CITY OF ALBUQUERQUE

October 14, 2022

**RE: Fitz Drinks
Conceptual Grading and Drainage Plans
Engineer's Stamp Date: No Date
Hydrology File: A14D049**

ENGINEER'S SEAL	FIIZ DRINKS ALBUQUERQUE, NM	DRAWN BY JL
	CONCEPTUAL GRADING AND DRAINAGE PLAN	DATE 7-14-22
		DRAWING
RONALD R. BOHANNAN P.E. #7868	TIERRA WEST, LLC 5571 MIDWAY PARK PL NE ALBUQUERQUE, NEW MEXICO 87109 (505) 858-3100 www.tierrawestllc.com	SHEET # GR-1
		JOB # 2022048

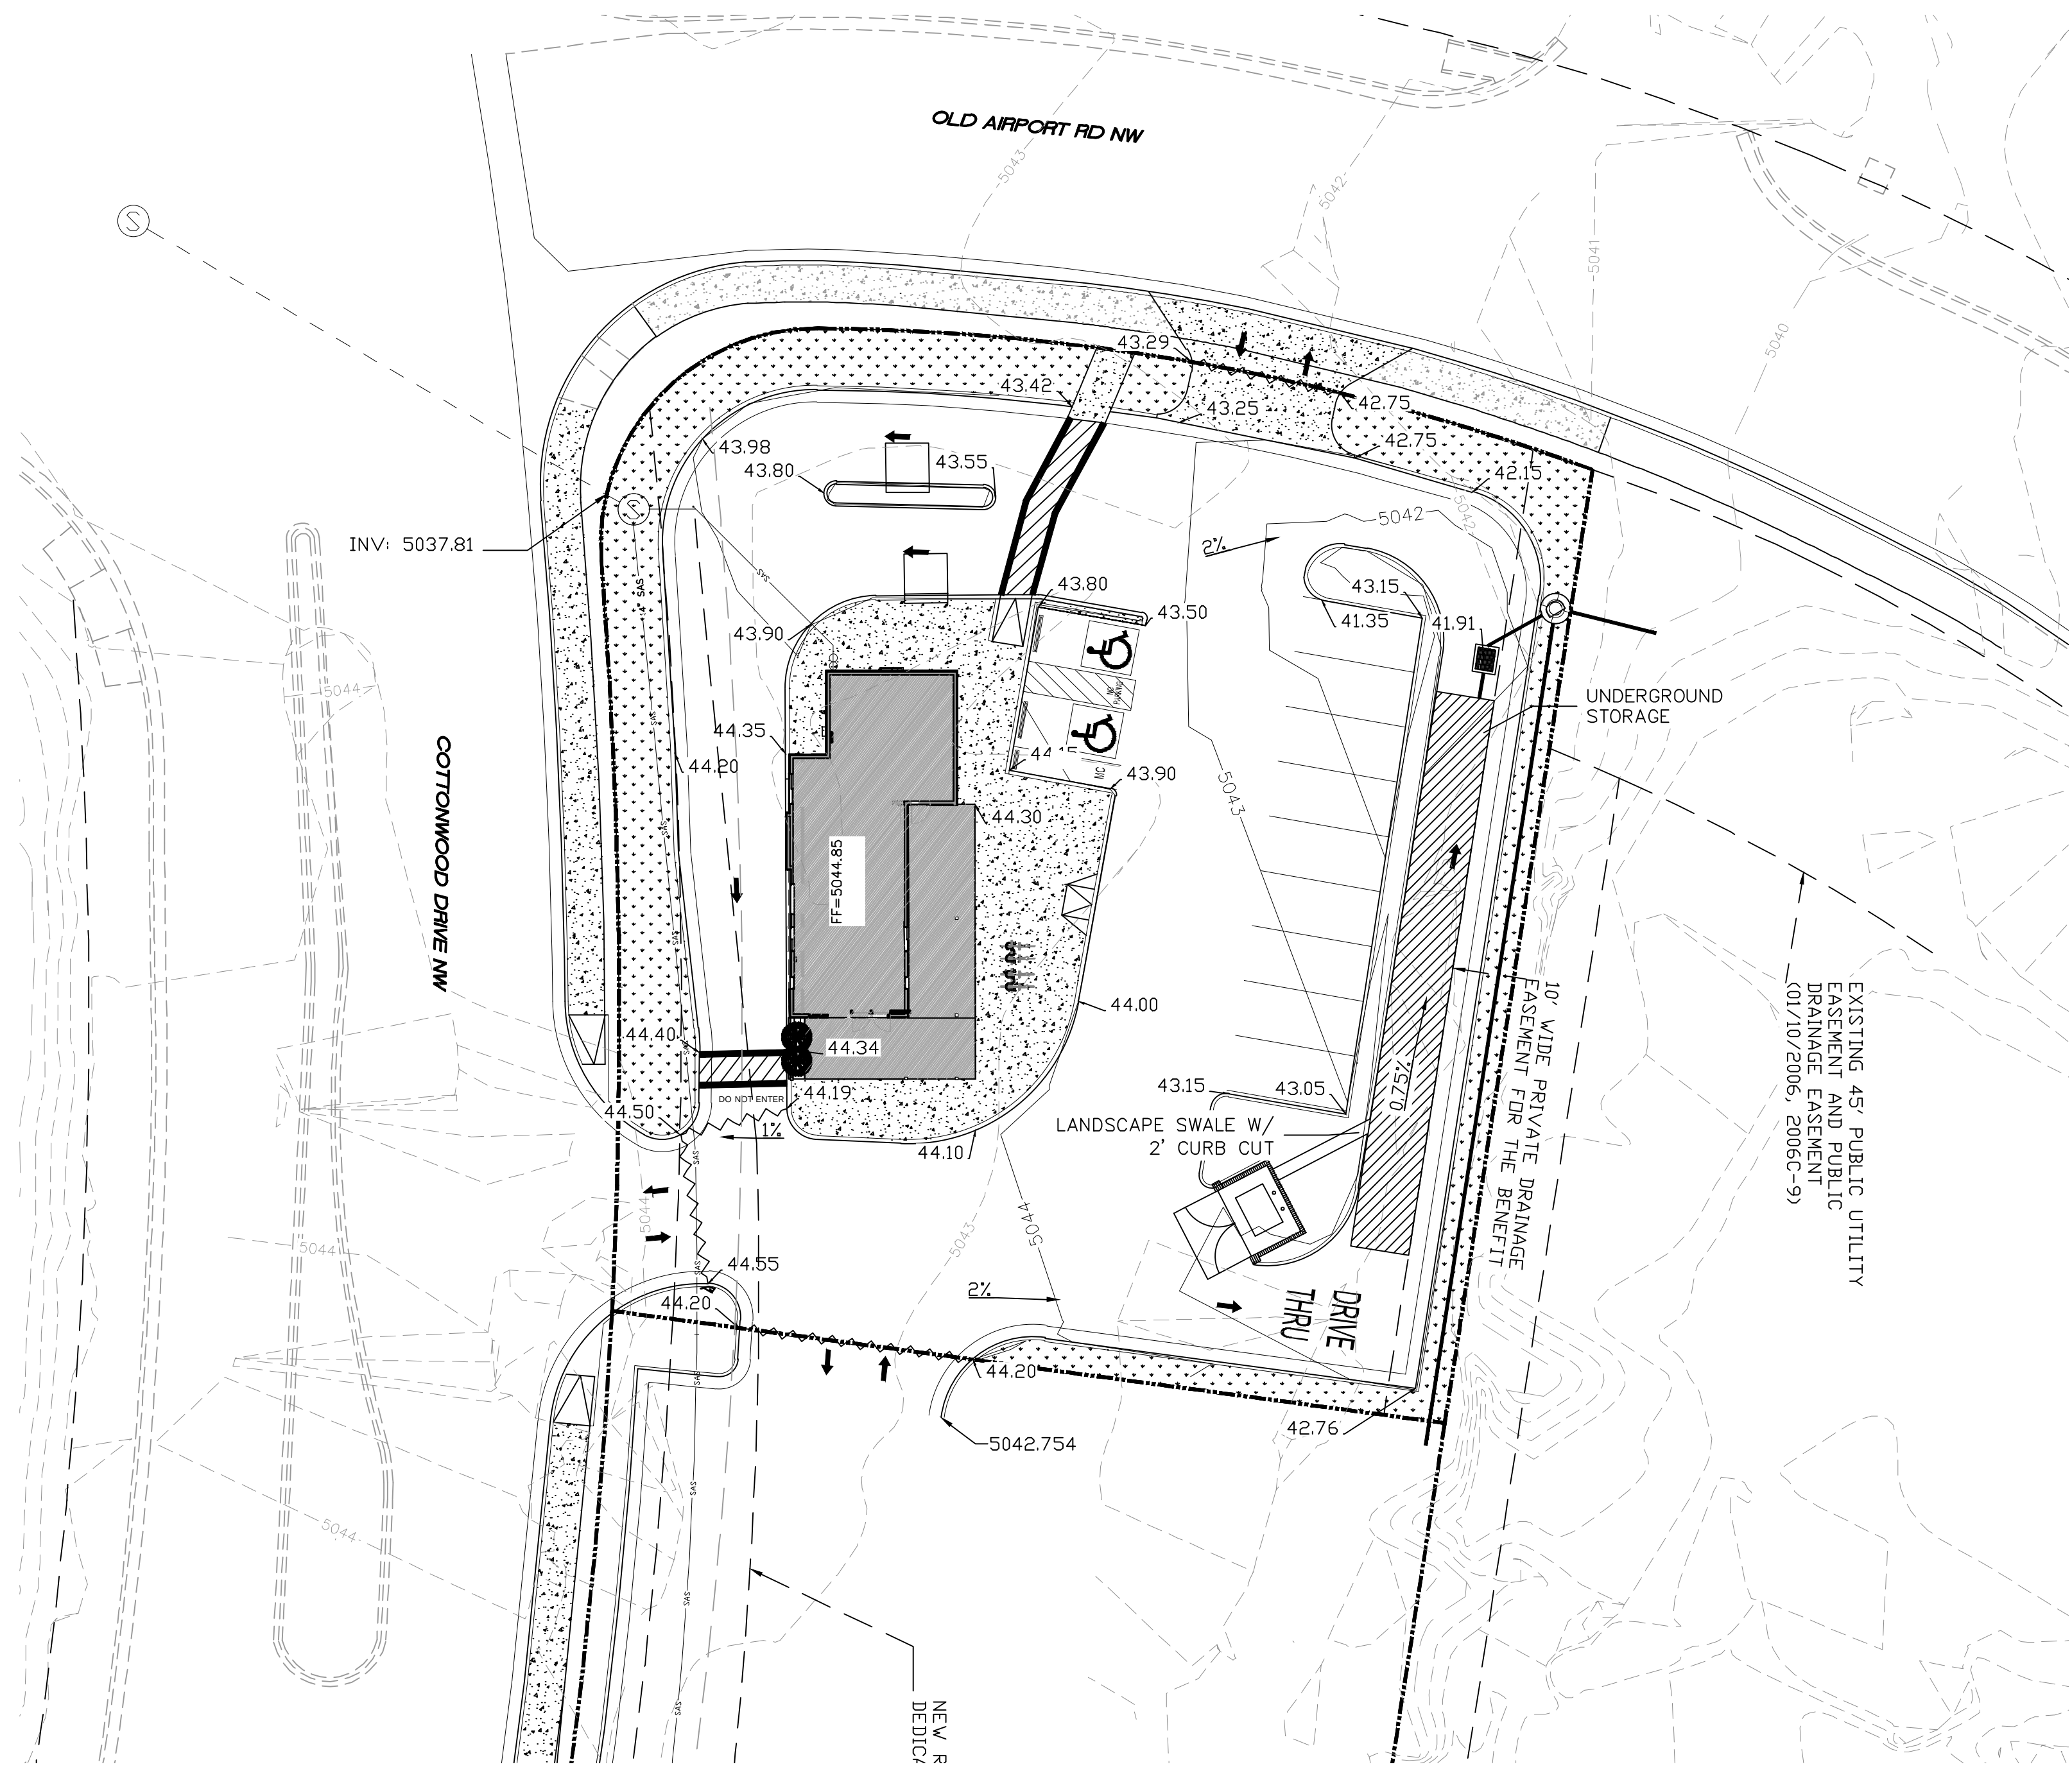
Based upon the information provided in your submittal received 09/30/2022, the Conceptual Grading & Drainage Plans are approved for action by the DRB on Platting action. However, the following comments need to be addressed prior to Building Permit approval of the above referenced project:

1. Provide more detailed design as needed in order to obtain Hydrology's approval.

City of Albuquerque
Planning Department
Development Review Services
HYDROLOGY SECTION
PRELIMINARY APPROVED
DATE: 10/14/22
BY: *Ronald R. Bohannon*
HydroTrans # A14D049
THESE PLANS AND/OR REPORT ARE CONCEPTUAL ONLY. MORE INFORMATION MAY BE NEEDED IN THEM AND SUBMITTED TO HYDROLOGY FOR BUILDING PERMIT APPROVAL.
